BELL SYSTEM PRACTICES
Teletypewriter and Data Stations

ADDENDUM P35.633
Issue 1, July, 1959
AT&TCo Standard

REPERFORATOR-TRANSMITTER UNITS 14F AND 14G REQUIREMENTS AND PROCEDURES

1.001 This addendum supplements Section P35.633, Issue 3.

Fig. 68

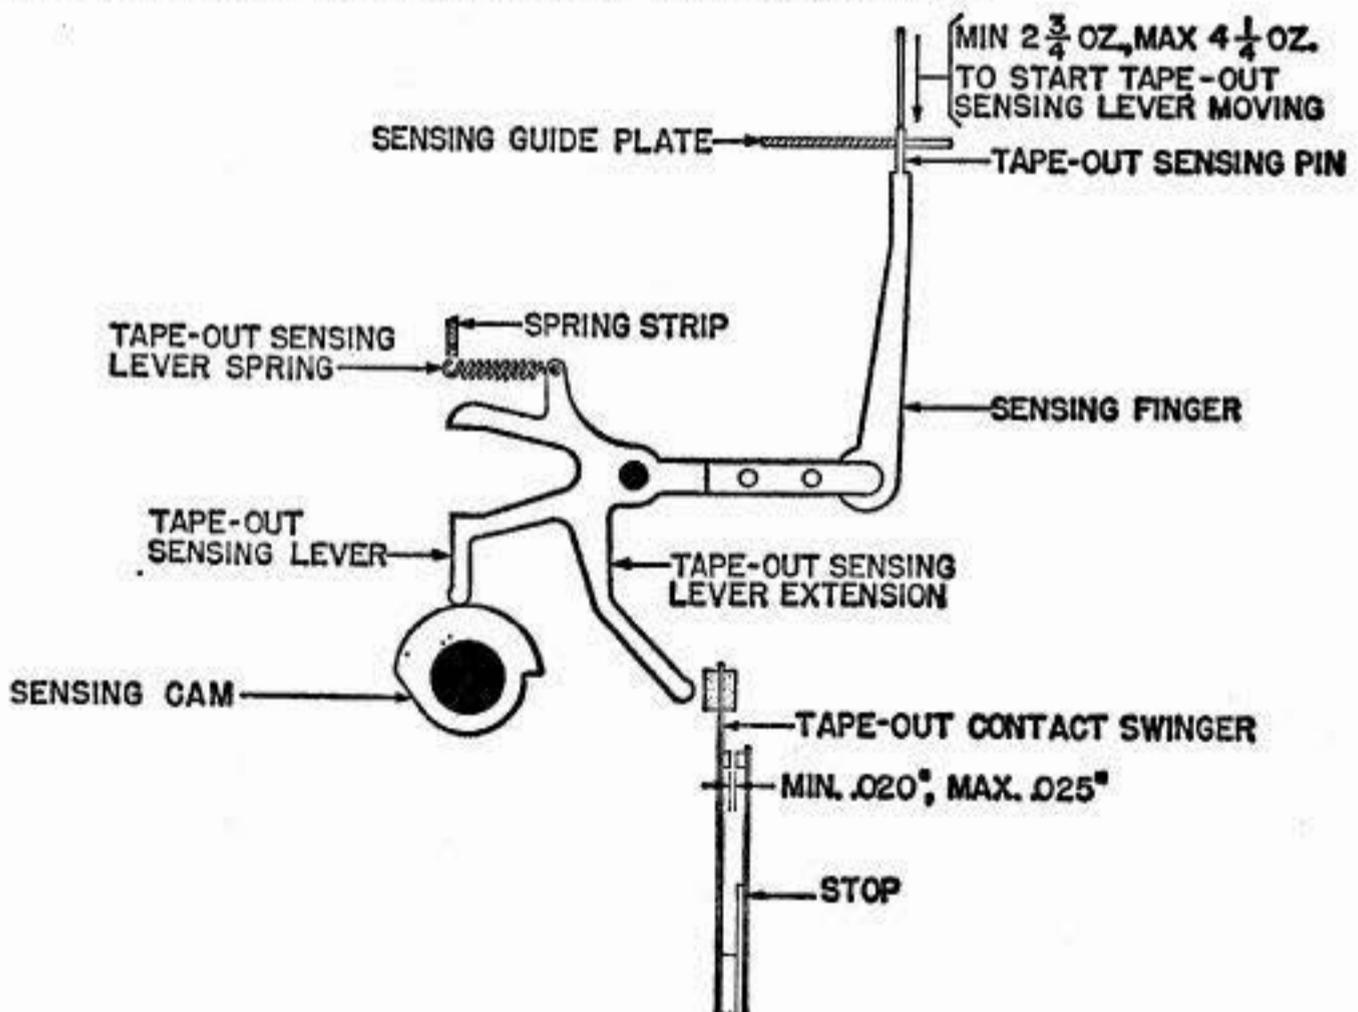
2.135 Tape-out Sensing-lever Spring: It should require a push as indicated in Fig. 68 to start the tape-out sensing-lever moving when the lever is in its uppermost position, the tape-out-contact swinger held away from the extension, and the pivoted transmitter held in its vertical position.

Note: In order to eliminate friction between the tape-feed lever and the tape-out lever, the tape-feed lever should be positioned toward the rear of the unit when measuring the spring tension.

(a) To gauge, apply the push end of the scale to the tape-out sensing-pin. (The tension may be easily determined by observing the tape-out sensing-lever spring.)

3. Distributor Contact requirement in 2.131 is revised to include the change authorized for this apparatus by BSP P98.519.
4. Tape-out Sensing-lever Spring requirement in 2.135 and Fig. 68 is revised to include the change authorized for this apparatus by BSP P98.438.

Fig. 71

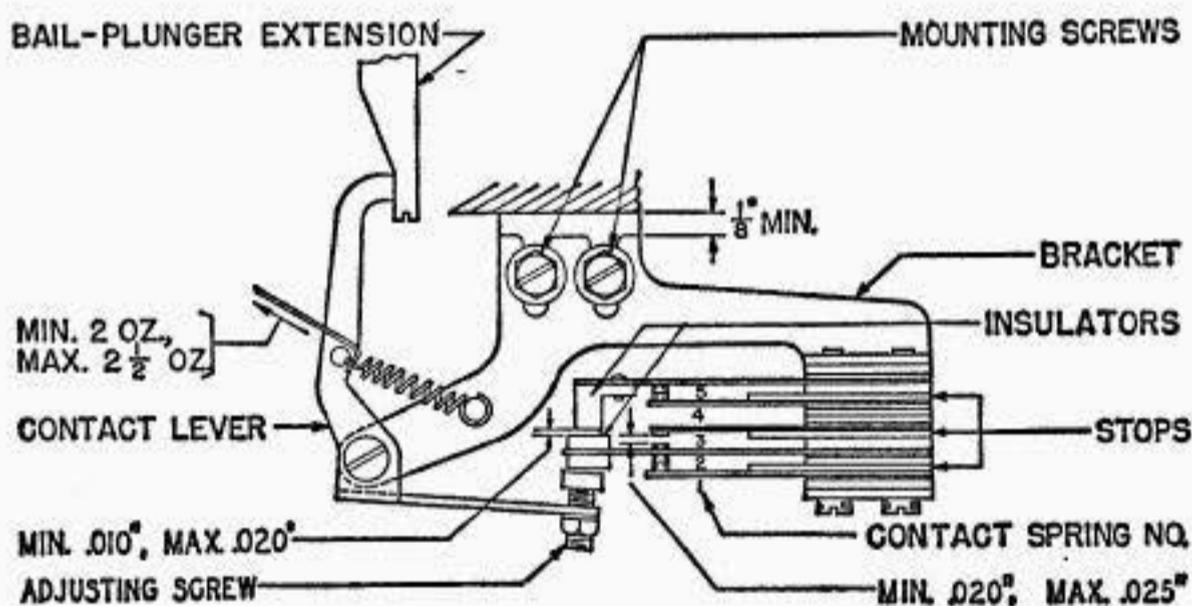
2.138(d) No. 2 Contact Spring:

(2) With the No. 5 spring returned to its unoperated position, there should be a clearance of Min 0.010", Max 0.020" between the No. 5 and No. 2 contact-spring tip-insulators. **Fig. 71**

(a) To adjust, bend the No. 2 contact spring between the contact and the tip insulator.

5. Universal Contacts, No. 2 Contact Spring requirement in 2.138(d)(2) and Fig. 71 is revised to include the change authorized for this apparatus by BSP P98.406.

Fig. 72

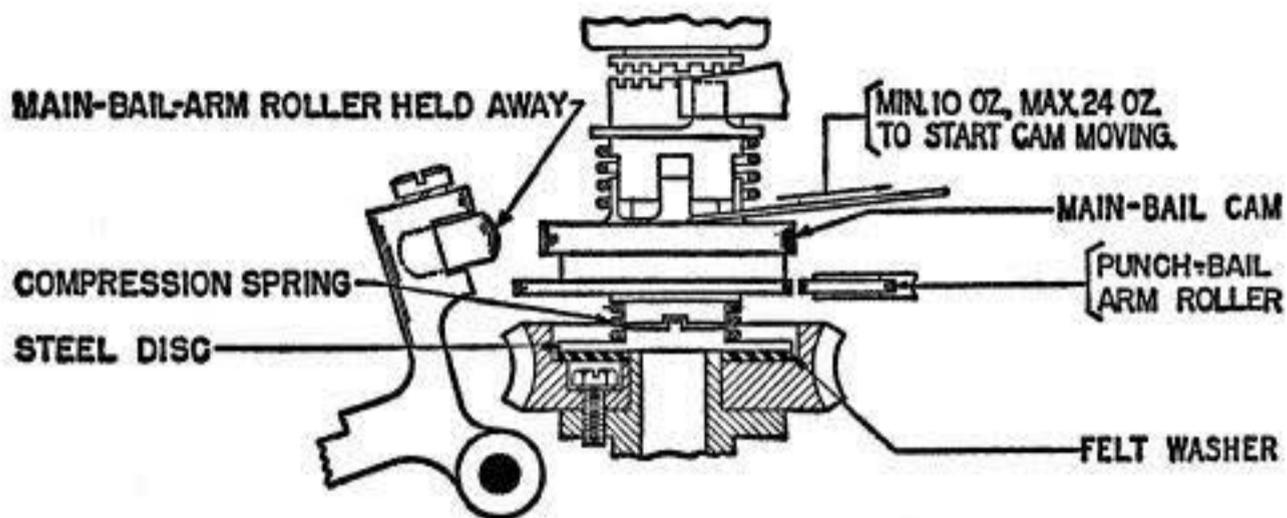
2.147 Mainbail-cam clutch-torque should be measured as follows after the motor has been running at least 10 minutes with the mainbail cam remaining stationary.

(a) It should require a pull as indicated in Fig. 72 to start the mainbail cam moving opposite to its normal direction of rotation. **Fig. 72**

(1) To gauge, press downward on the mainbail so as to move the mainbail roller away from its cam. At the same time, hold the cam-lever roller and the punch-bail-arm roller away from their cams. Hook the scale in the screw hole on top of the mainbail cam and pull at a right angle to the radius.

6. Mainbail-cam Clutch-torque requirement in 2.147 and Fig. 72 is revised to include the change authorized for this apparatus by BSP P98.520.
7. Tape-feed-indicator-contact Assembly in 2.152(c) and Fig. 77 (B) is revised to include the change authorized for this apparatus by BSP P98.406.

Fig. 77

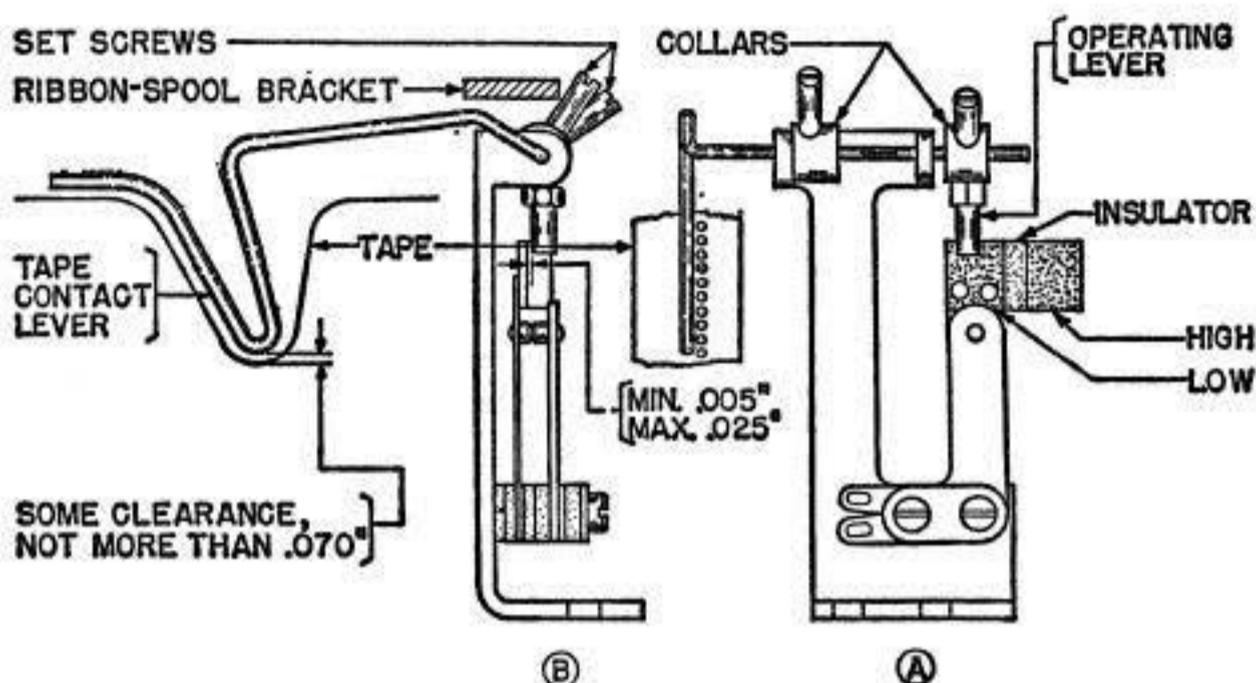
2.152 Tape-feed-indicator-contact Assembly

(c) With the tape-lever arm in its central position on the tape and the contact-spring-operating lever opposite the center of the low part of the insulator on the long contact-spring, there should be a clearance of Min 0.005", Max 0.025" between the contact-spring-operating lever and the insulator.

(1) To adjust, loosen the rear-collar-setscrew post so that the collar will be friction-tight on the tape-contact lever. The collar holding the contact-spring-operating lever can then be positioned to give proper clearance between the operating lever and the insulator.
